Value Engineering Final Report

St. Mary Diversion and Headworks Replacement and ESA Modifications

K8T-1510-GP10-008-00-0-1

June 1, 2011

Figure 8 - Alternative Building Layout

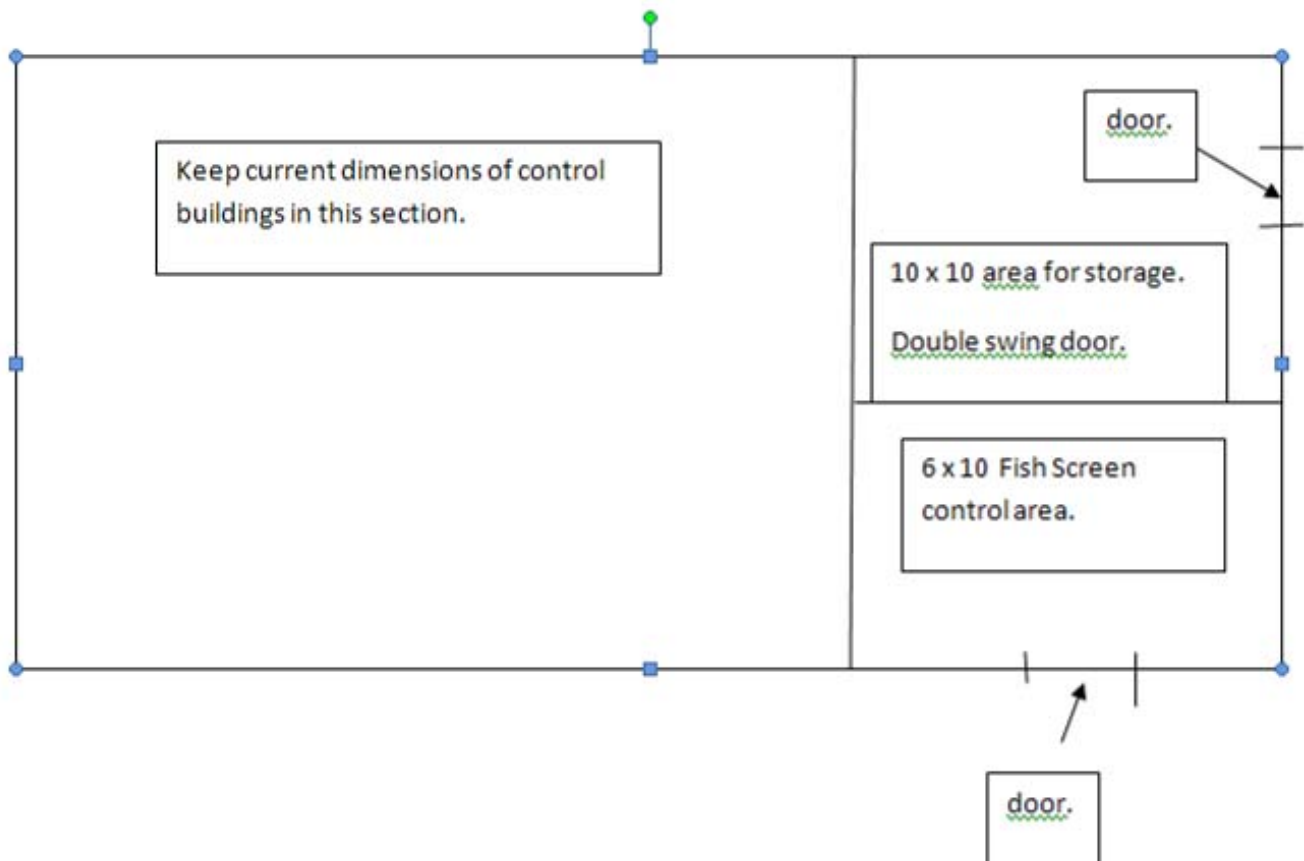
Proposal Description: This proposal is to combine the two Control Buildings into one building located where the Fish Screen control building currently sits (see Figure 8). We would also add an area to store some equipment (see Figure 7).

Changes from the Baseline Design: One building instead of two (or more). See Figure 9.

Figure 10 - PIT Tag Antenna

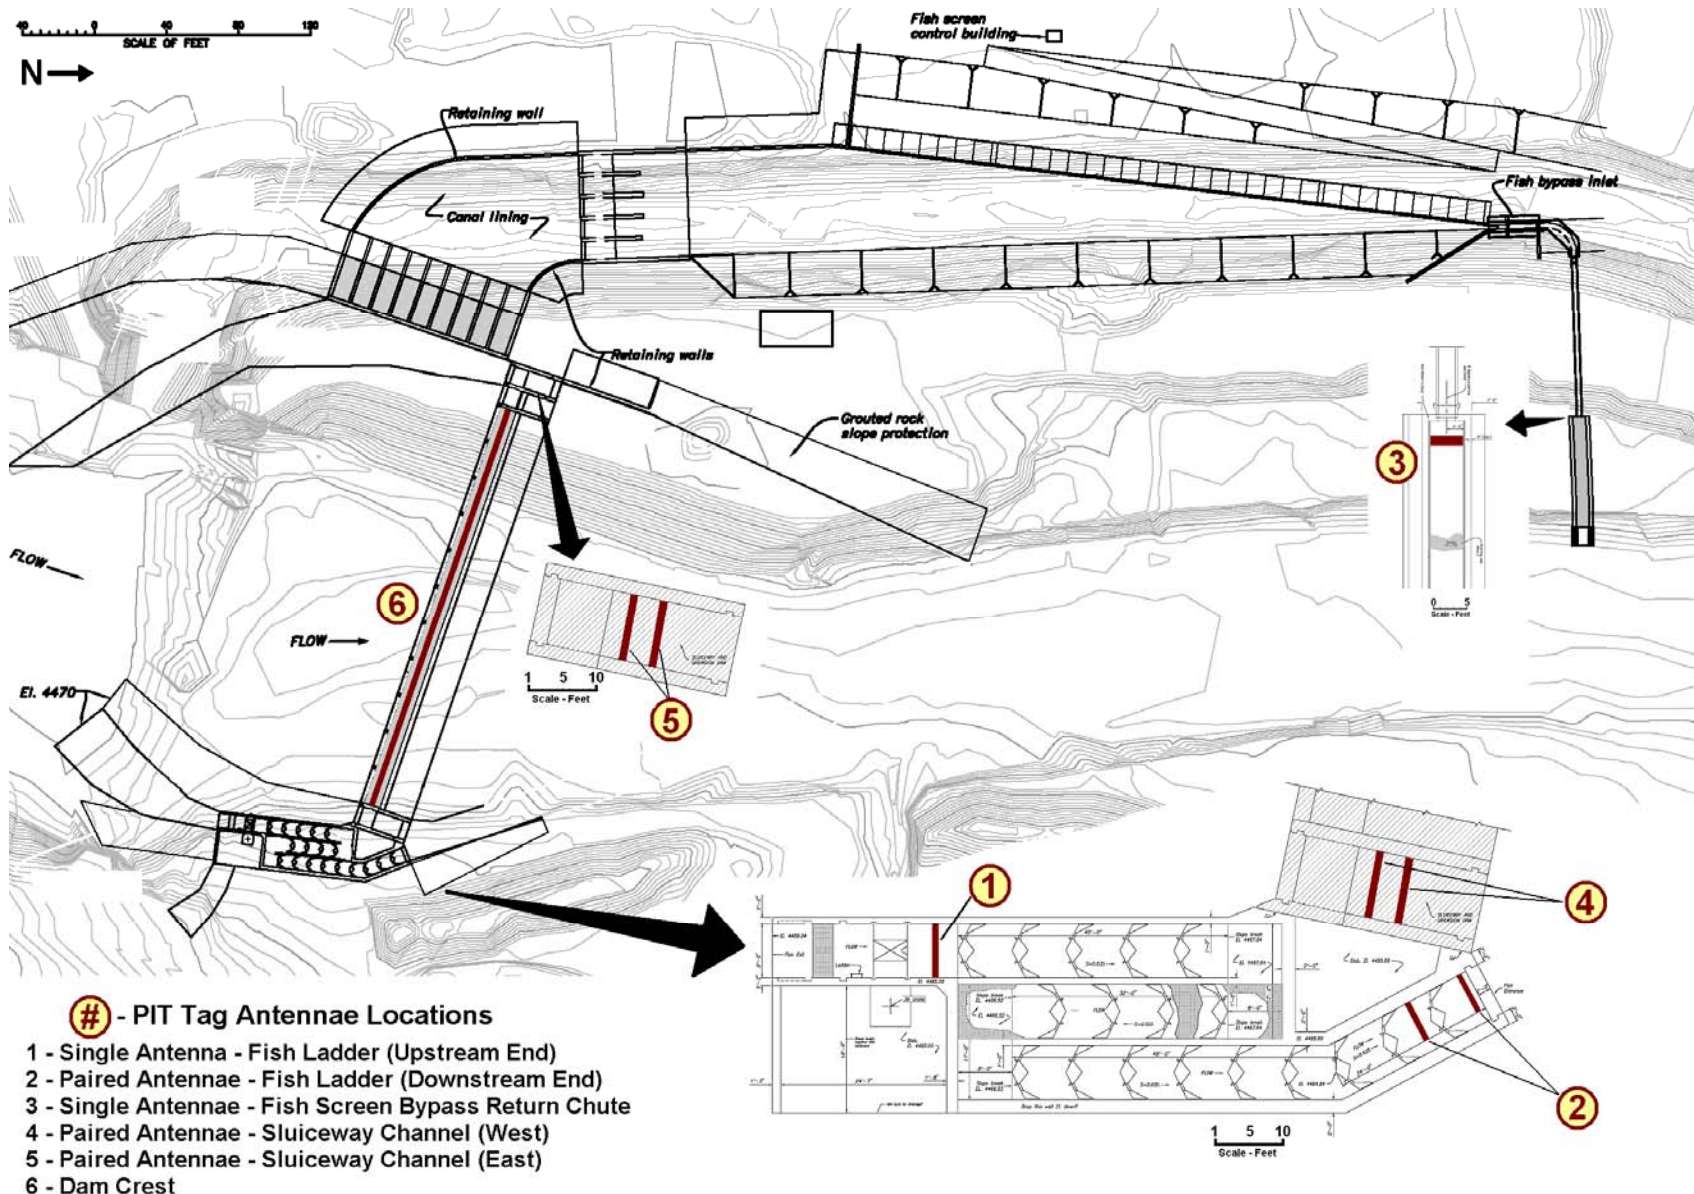
- Pass-by Antennae (flat-plate) would be used on the dam crest and in the sluiceways.
- Pass-Through Antennas would be used in the fish ladder and fish bypass outlet.

During the development of this proposal, it was discovered that the technology does not exist yet to cover the crest of the dam (figure 10, location 6) at the expected flows. Provided cost, therefore, does not cover this system for the dam crest. Contactor stated that the technology to cover the crest is only a year or two into the future.

Figure 14 - Modified Bypass Chute Layout

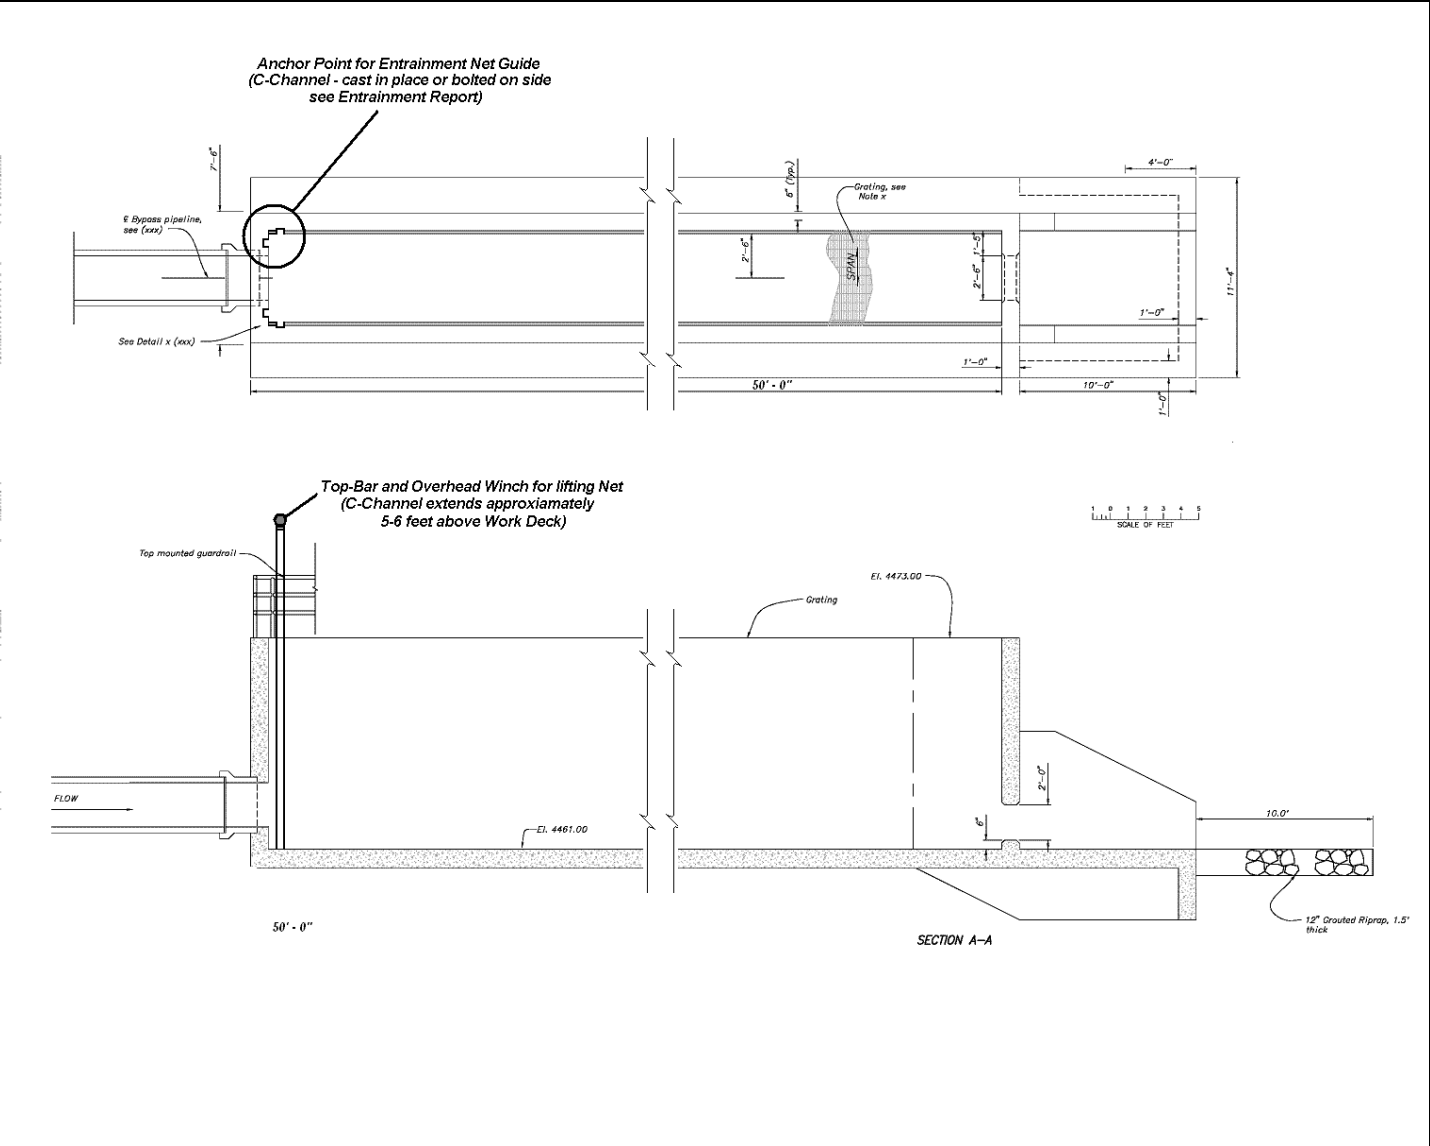
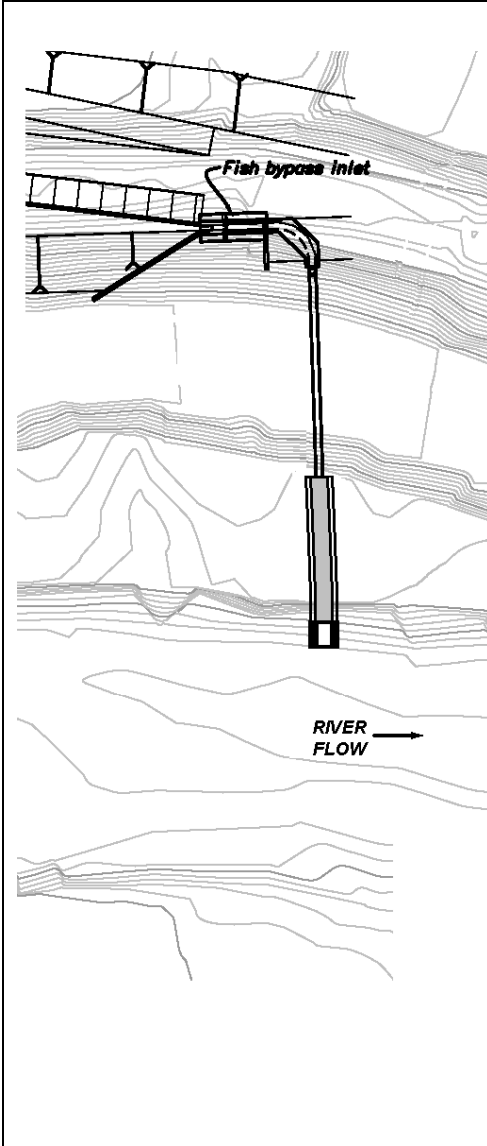
Proposal Description: Replaces the downstream section of the bypass pipe with a modified concrete channel to accommodate fish sampling gear

- This would replace the proposed designs of the St. Mary Diversion fish bypass pipe and outlet.
- This addition replaces the lower 34 feet of the bypass pipe by extending the downstream chamber 34 feet west towards the canal, resulting in 50 feet of open top concrete channel (chute).
- This modification is being done to facilitate fish sampling associated with fish screening and bypass operations while avoiding over-river safety issues and sampling difficulties.
- Sampling devices are “flow-through” and would not impact bypass outlet flow.
- Fish sampling gear attachment points would utilize either temporary or permanent concrete anchors.

Changes from the Baseline Design: Additional chute length to accommodate fish monitoring and ease pipe cleanout.
